**Subject: Hanson Glebe Island Concrete Batching Plant – Response to TAS Air Quality Review**

Please find detailed below our responses to the Todoroski Air Sciences (TAS) commentary on *Hanson Glebe Island Concrete Batching Plant Air Quality Assessment*, ("the AQIA") as conducted by ERM, (formerly Pacific Environment), (PE, 2018).

Figure 1 – Comparison of 2015 Wind Roses – BoM Sydney Airport and DPIE (formerly OEH) Rozelle

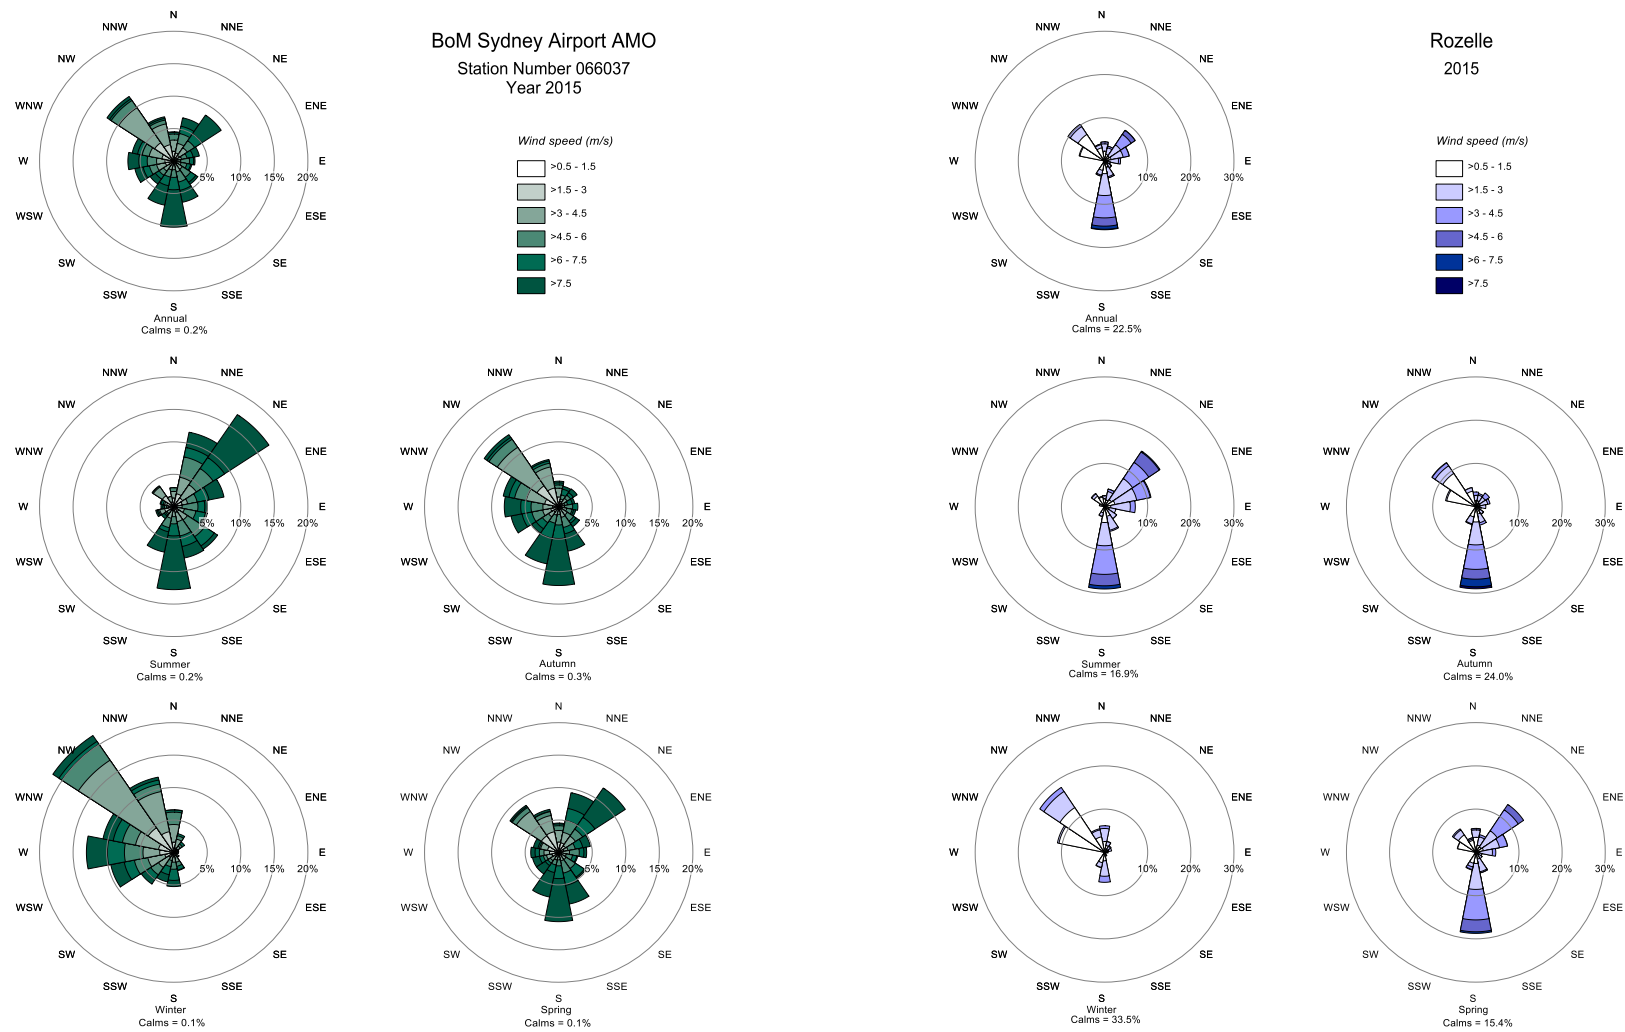
*This response does not adequately address the issues raised in the independent review and is based on factually incorrect or misleading assertions in regard to the key matters. For example, Figure 7-2 in the AQA presents the 2015 windroses for Rozelle. The annual and seasonal windroses do not show "winds from all directions under all seasons". The figure clearly shows almost no winds from the southwest to west which indicates that there is likely sheltering from the very large, nearby tree in this direction.*

*These data significantly bias the wind data used in the assessment and will lead to invalid results when used with AERMOD. This issue could be overcome by the use of an alternate model such as TAPM, CALMET and CALPUFF, which is more suitable for dealing with the locality. The lack of supporting evidence for selecting the 2015 year to be representative of conditions is not responded to.*

The updated TAS commentary is not supported. As shown in the wind roses, a balance of winds across all directions is captured across all of the seasons. It was not intended to state that all wind directions were captured within each individual season.

To provide context on the suitability of these winds, a comparison against the Bureau of Meteorology (BoM) Sydney Airport automatic weather station data was undertaken for the year 2015. These data are shown in Figure 1 (in green) as annual and seasonal wind roses alongside data from the DPIE Rozelle data (blue).

Figure 1 shows a consistency in dominant winds across annual and individual seasons as per the following:

- Dominance of north-easterly and southerly winds in summer (both Sydney Airport and Rozelle charts)
- Dominance of north-westerly and southerly winds in autumn (both Sydney Airport and Rozelle charts)
- Dominance of north- westerly winds in winter (both Sydney Airport and Rozelle charts)
- Dominance of southerly and north-easterly winds in spring (both Sydney Airport and Rozelle charts)
- Low frequency of south-westerly winds (both Sydney Airport and Rozelle charts).

On this basis, the statement “*These data significantly bias the wind data used in the assessment and will lead to invalid results when used with AERMOD*” is not supported, noting that agreement with regional winds is shown both annually and seasonally. Further, the low frequency of south-westerly winds is considered representative of the region, and not due to the presence of a tree near to the DPIE Rozelle AQMS.
